Statement of Response to ABP's Opinion

**Proposed Development at Concorde Industrial Estate, Naas
Road, Dublin 12**

John Spain Associates

May 2019

1.0 Design Development Following Pre-application Consultations/An Board Pleanala Opinion

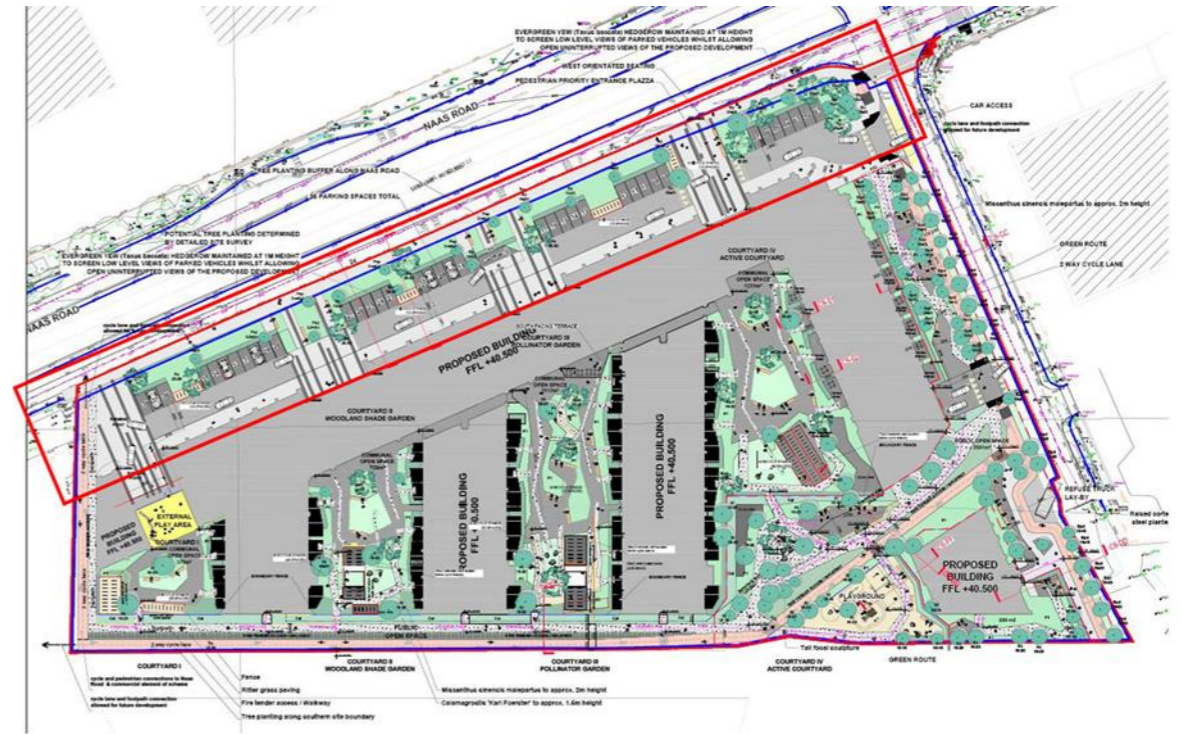
2.0 Interface between the proposed development and the Nass Road:

Above: In the previous layout, the site frontage contained earthen berms, ground cover and green route and trees to screen views of the proposed development from Naas Road. A single shared surface plaza and southwest orientated seating were proposed.

In the current layout, shown above, the earthen berms have been removed and the quantity of trees reduced to a select number of strategically placed specimens underplanted by a low ground cover. Three additional shared surfaces, pedestrian access paths and southwest orientated seating areas were introduced to provide a greater degree of pedestrian permeability and intervisibility between the public footpath along Naas Road and front of the proposed development. Native evergreen yew (*Taxus baccata*) hedgerows maintained to 1.00m height were introduced to screen low level views of parked vehicles and loading bay. (ref drawing 18-489-PD-01)

2.1 Pedestrian and cycle routes connections with the public road network:

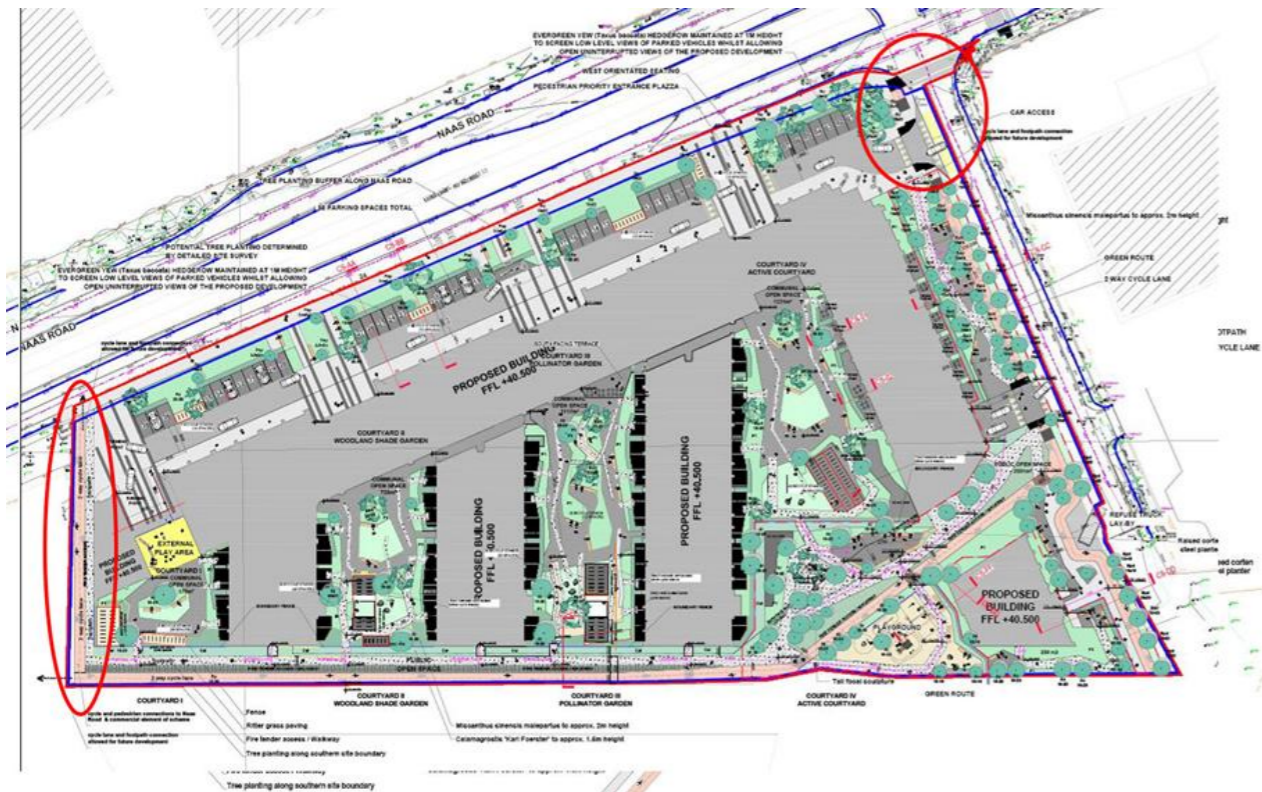
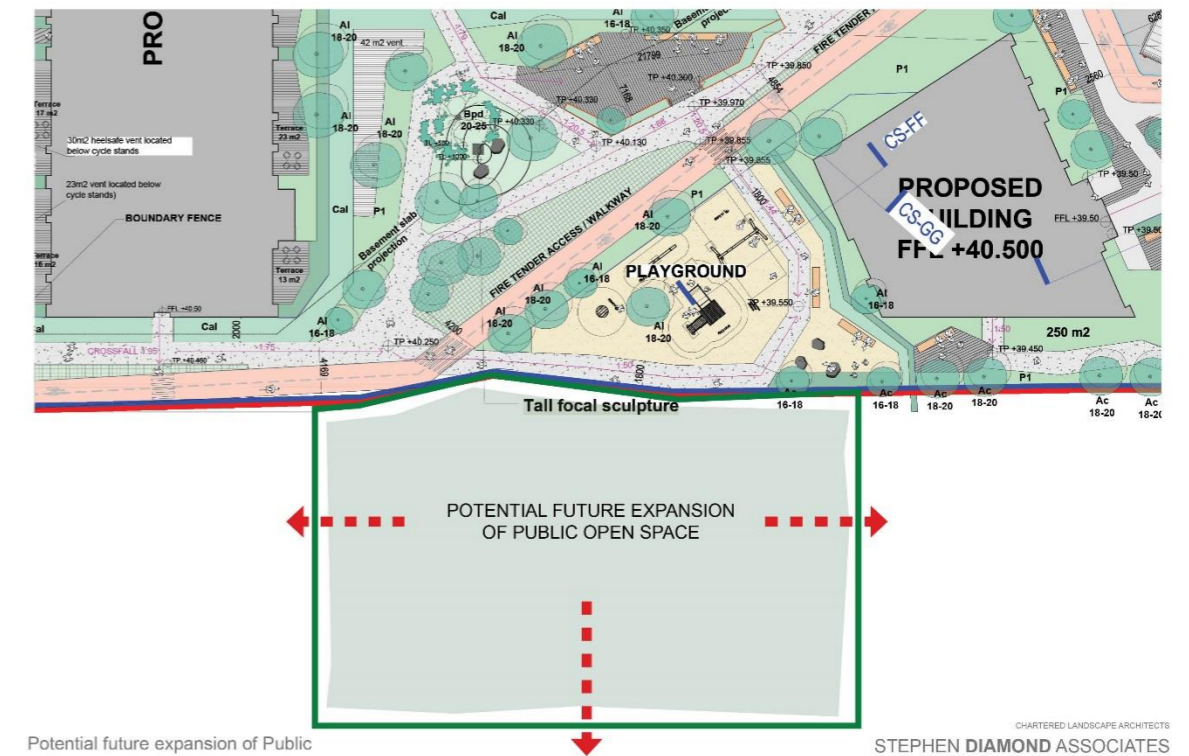
Above: Previous layout cycling and pedestrian connections.

Above: In the current layout cycling and pedestrian connections were provided from the western end of the proposed footpath and cycle route at the south of the site back to the Nass road at the western end of the site. On the northeastern corner the cycling connection was revised by the engineers to meet LAP/green route. (ref drawing 18-489-PD-01)

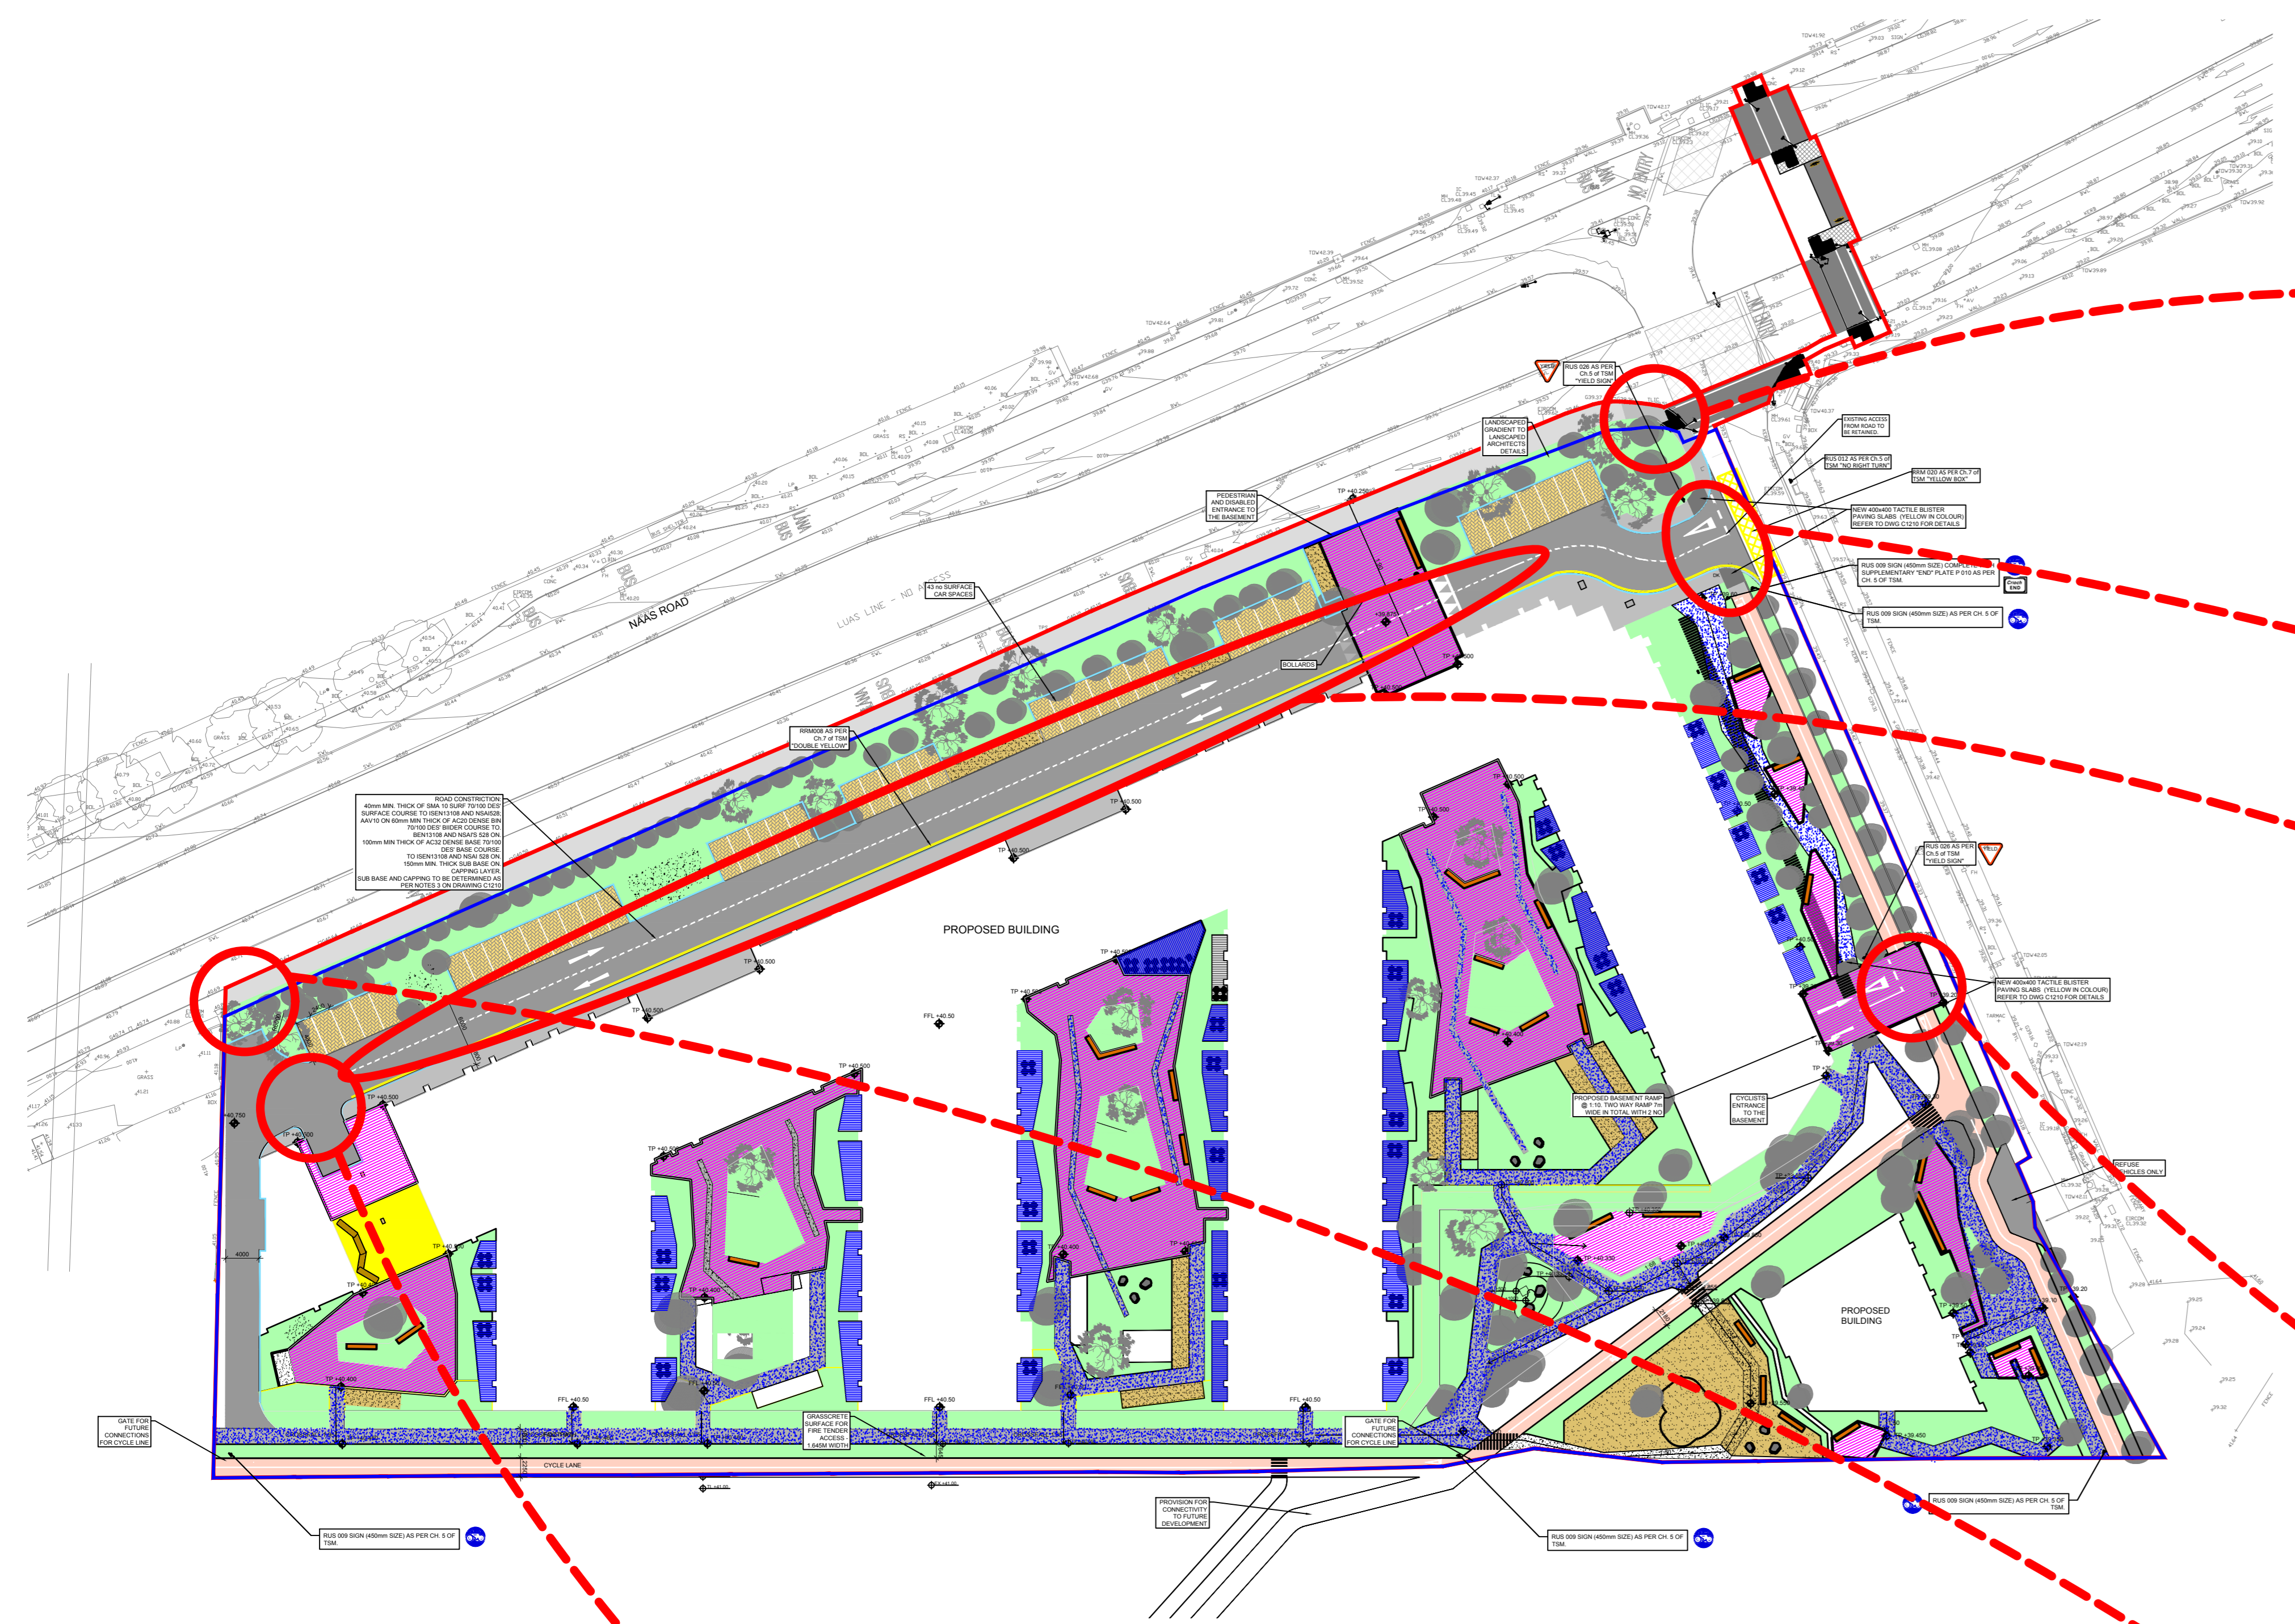
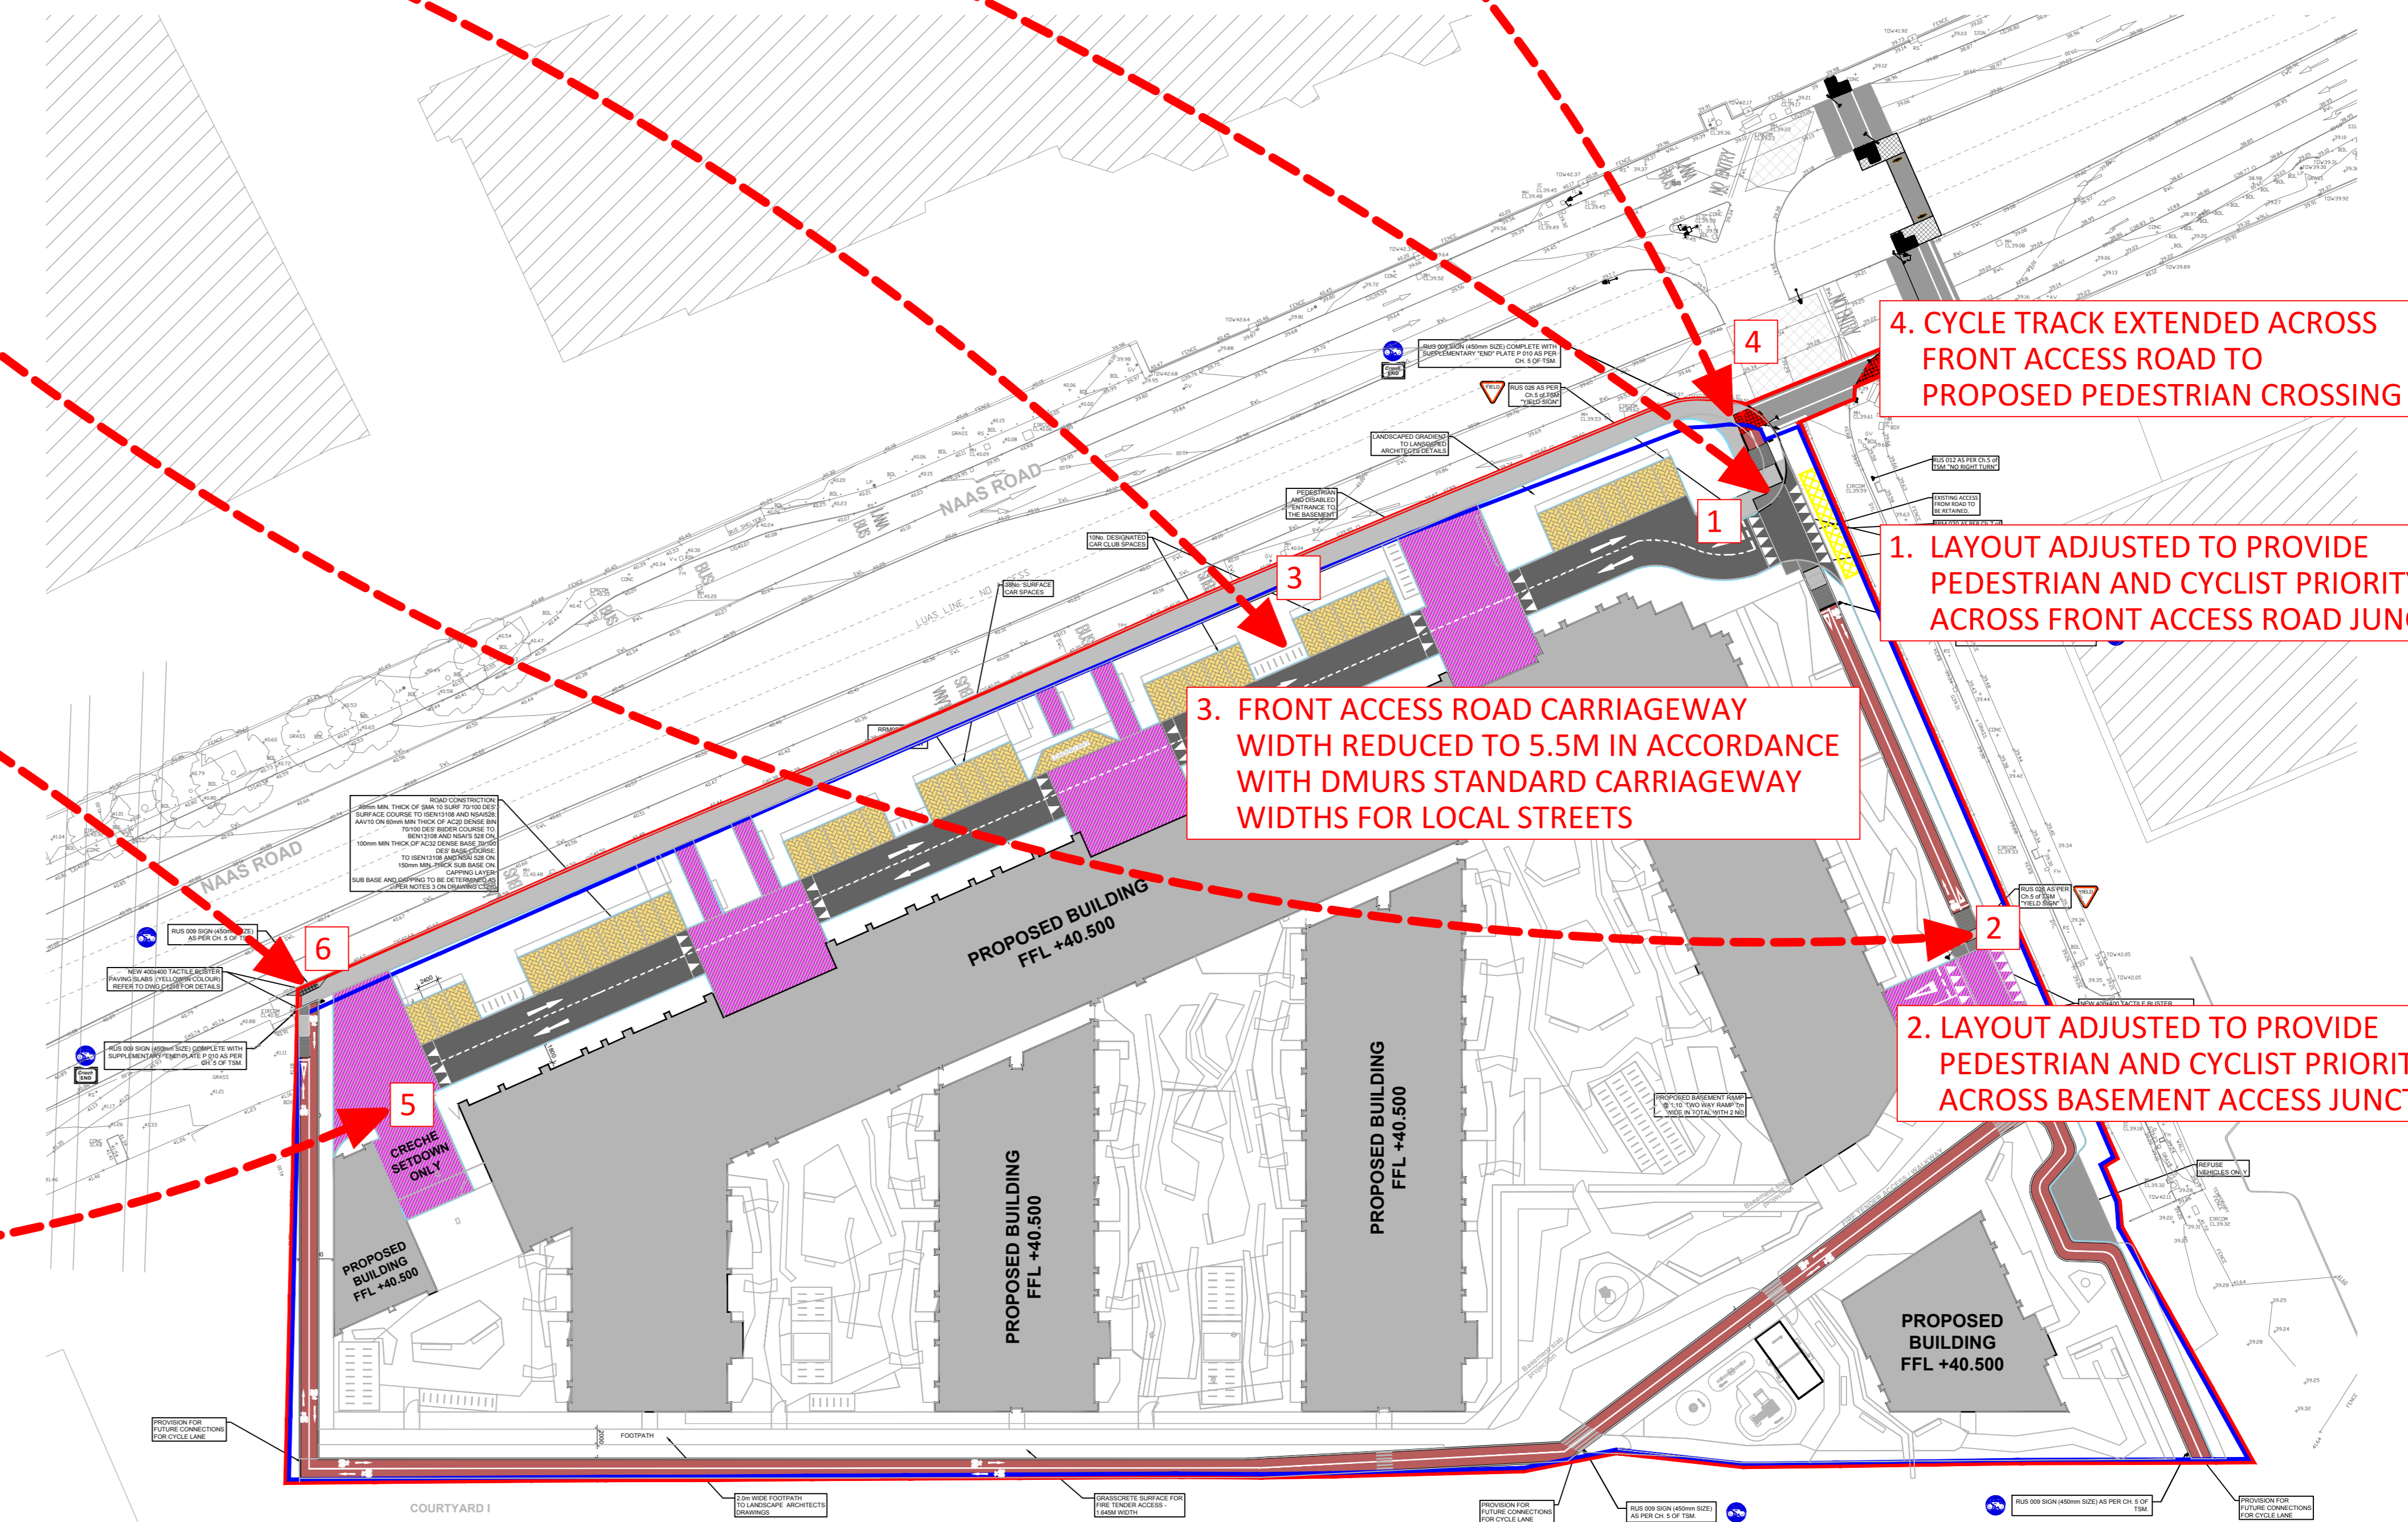
- 2.17 Following consultation with Dublin City Council it was recommended that a pedestrian crossing be provided across the Naas Road as indicated in the Engineering Reports and Drawings subject to agreement with Transport Infrastructure Ireland and Dublin City Council Roads Department.

- 6. PROVISION OF CONNECTION TO PUBLIC FOOTPATH AND ROAD NETWORK AT NORTH WEST CORNER OF SITE
- 5. VEHICLE TURNING BAY ADJUSTED TO FACILITATE EXTENSION OF CYCLE TRACK AND FOOTPATH ALONG WEST BOUNDARY OF SITE

- 4. CYCLE TRACK EXTENDED ACROSS FRONT ACCESS ROAD TO PROPOSED PEDESTRIAN CROSSING
- 1. LAYOUT ADJUSTED TO PROVIDE PEDESTRIAN AND CYCLIST PRIORITY ACROSS FRONT ACCESS ROAD JUNCTION
- 3. FRONT ACCESS ROAD CARRIAGEWAY WIDTH REDUCED TO 5.5M IN ACCORDANCE WITH DMURS STANDARD CARRIAGEWAY WIDTHS FOR LOCAL STREETS
- 2. LAYOUT ADJUSTED TO PROVIDE PEDESTRIAN AND CYCLIST PRIORITY ACROSS BASEMENT ACCESS JUNCTION
